Petition R16-05 Ervin Cook Road Conditional District Rezoning

PART 1: PROJECT SUMMARY

PART 2: REZONING/SITE PLAN ISSUES

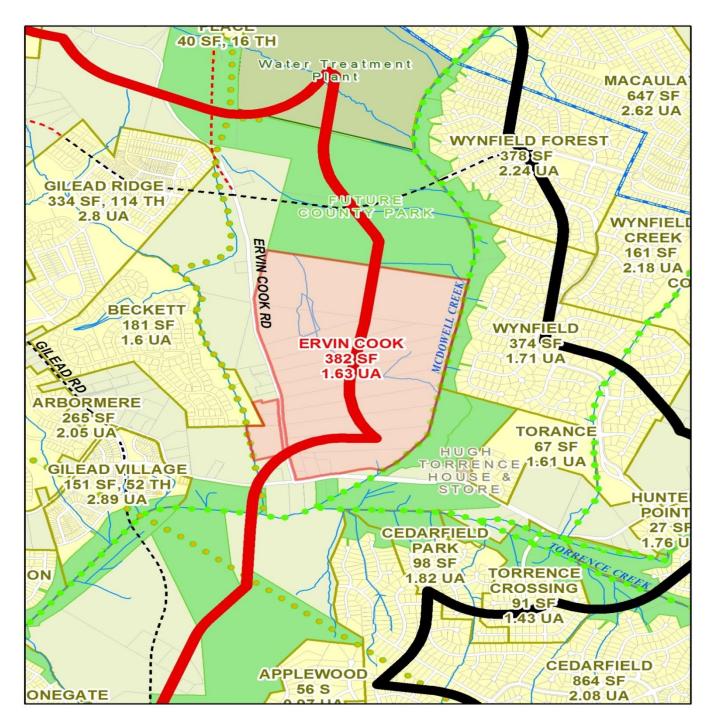
- Comment: The proposed CD Rezoning is split by the "High and Low Intensity Areas" line from the 2030 Community Plan (see map below). The eastern half of the project is located within the area between the High and Low Density line and the western half (along Ervin Cook Road) is located outside of the line.

- <u>Comment:</u> The proposed Ervin Cook Road subdivision has a <u>density of 1.63-units per acre</u>. The surrounding developments average 2.08, as shown on map below:
